# UNITED STATES PATENT AND TRADEMARK OFFICE

<b>Office Action Summary</b>	<b>Application No.</b> 10/788,931	<b>Applicant(s)</b> SCHROTH ET AL.	
	<b>Examiner</b> Debra Wolfe	<b>Art Unit</b> 3725

## DETAILED ACTION

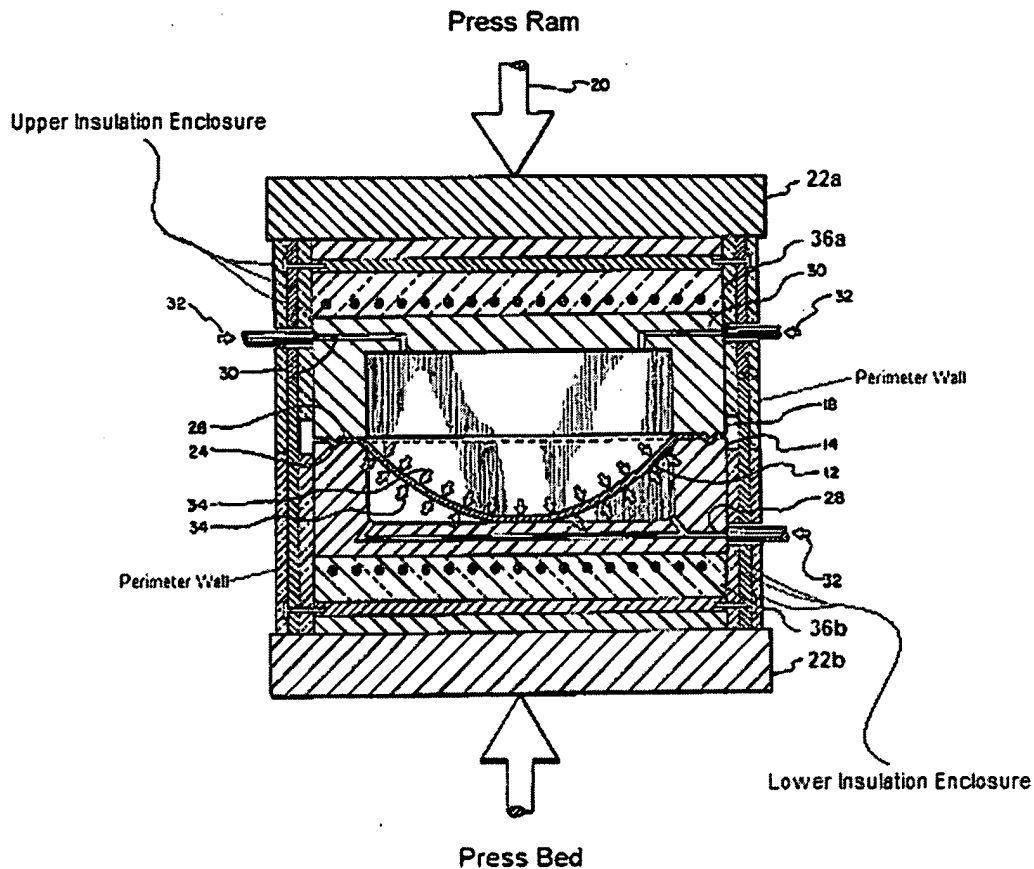
1. Claims 1-3, 7 and 10 are rejected under 35 U.S.C. 102(b) as being anticipated by Ghosh (U.S. Patent # 4,352,280). Ghosh discloses a compression forming apparatus for sheet material having an upper and lower heater plate (36) mounted to a non-heated press, via platens (22) mounted there between and to the press, wherein the heater plates are integrally heated; a first non-integrally heated forming tool (upper die portion 18) is mounted to the upper heater plate (36) and a second non-integrally heated forming tool (lower die portion 14) is mounted to the lower heater plate (36) whereby the forming tools (18, 14) are separately heated by the heater plates; a first and second insulation enclosure including a base portion positioned between each upper and lower heater plate and the presses (See col. 5, line 11) and a perimeter wall (See FIG below) surrounding each upper and lower heater plates and the first and second forming tools (18, 14) whereby when the apparatus closes together the upper insulation enclosure fits within a portion of the lower insulation enclosure to define a closed vessel thereby insulating the forming tools (18, 14) from the surrounding environment (See FIG below; notice different markings on perimeter wall).

2. Claim 13 is rejected under 35 U.S.C. 102(b) as being anticipated by Ghosh (U.S. Patent # 4,352,280). Ghosh discloses a compression forming apparatus for sheet material having a first integrally heated heater plate (36a) mounted to a press bed with a first layer of insulation (See

col. 5, line 11) positioned between the integrally heated heater plate (36a) and the press bed; a first forming tool (lower die portion 14) mounted to the integrally heated heater plate (36a) whereby the first forming tool (14) is separately heated by the integrally heated heater plate; a second integrally heated heater plate (36b) mounted to a press ram with a second layer of insulation positioned between the second integrally heated heater plate (36b) and the press ram (See col. 5, line 11); a second forming tool (upper die portion 18) mounted to the second integrally heated heater plate whereby the second forming tool (18) is separately heated by the second integrally heated heater plate (36b); and an insulation enclosure (See FIG below) partially surrounding at least one of the heater plates (36) and forming tools (14, 18) thereby providing insulation from the outside environment. Although Ghosh does not disclose in the drawings a press bed or press ram, column 4, line 58 states that the apparatus shown in FIG 2 is attached to a press and it is known in the art that a press contains a press bed and a press ram, therefore the examiner asserts the above position that the first and second heated heater plates are mounted to a press bed and a press ram.

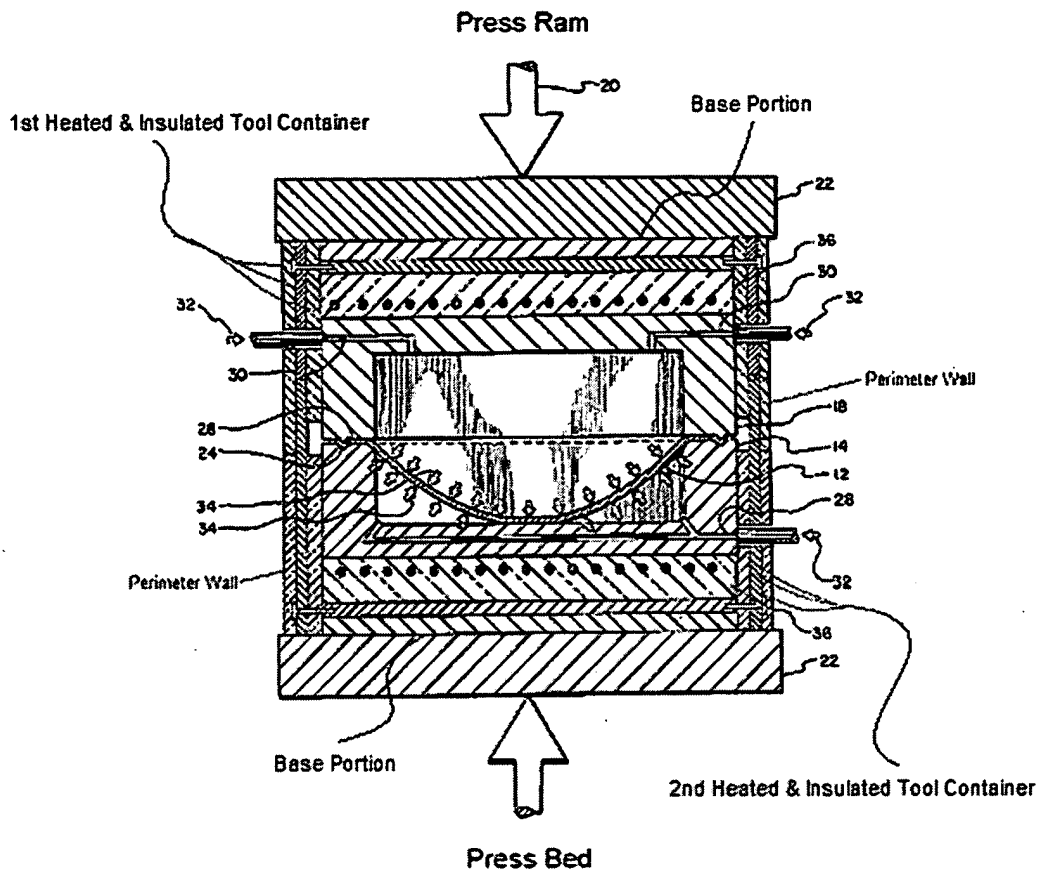
4. Claim 11 is rejected under 35 U.S.C. 103(a) as being unpatentable over Ghosh (U.S. Patent # 4,352,280) in view of Herdzina (U.S. Patent # 5,277,047). Ghosh discloses a compression forming apparatus for sheet material having a first heated and insulated tool container (See FIG below) including a tool heater plate (heater 36) adapted for attachment to a platen (22) of a press (See col. 4, line 59), an insulation enclosure having a base portion (See FIG below) between the tool heater plate (36) and platen (22) (See col. 5, line 22) and a perimeter wall portion (See FIG below) extending in a substantially perpendicular direction away from the

base portion and surrounding tool heater plate (36), a forming tool (upper die portion 18) mounted to the tool heater plate (36) such that the forming tool (18) is separately heated by the tool heater plate (36); and a second heated and insulated tool container (See FIG below), opposed to the first heated and insulated tool container (See FIG below), including a second tool heater plate (36b) adapted for attachment to an opposed platen (22b) of a press (See col. 4, line 59), a second insulation enclosure having a base portion between the second tool heater plate (36b) and the opposed platen (22b) and a perimeter wall portion (See FIG below) extending in a substantially perpendicular direction away from the base portion and surrounding second tool heater plate (36b), a second forming tool (lower die portion 14) mounted to the second tool heater plate (36b) such that the second forming tool (14) is separately heated by the second tool heater plate (36b). It is also disclosed by Ghosh when the apparatus closes together the upper insulation enclosure fits within a portion of the lower insulation enclosures to define a closed vessel thereby insulating the forming tools (18, 14) from the surrounding environment (See FIG below; notice different markings on perimeter wall). Ghosh discloses the invention substantially as claimed except for wherein a load bearing spacer is positioned between the first heater tool plate and platen and a second load bearing spacer is positioned between the second heater tool plate and platen. However, Herdzina discloses a conversion system tooling heater having a load bearing insulated spacer to minimize the heat loss to the lower chase. It is also noted that Ghosh does provide insulating plates to hold the heaters against the die and to confine the heat to the die (See col. 5, line 11). Therefore it would have been obvious to one of ordinary skill in the art at the time the invention was made to modify Ghosh with a load bearing insulating spacer as taught by Herdzina in order to confine the heat to the die and minimize heat loss.
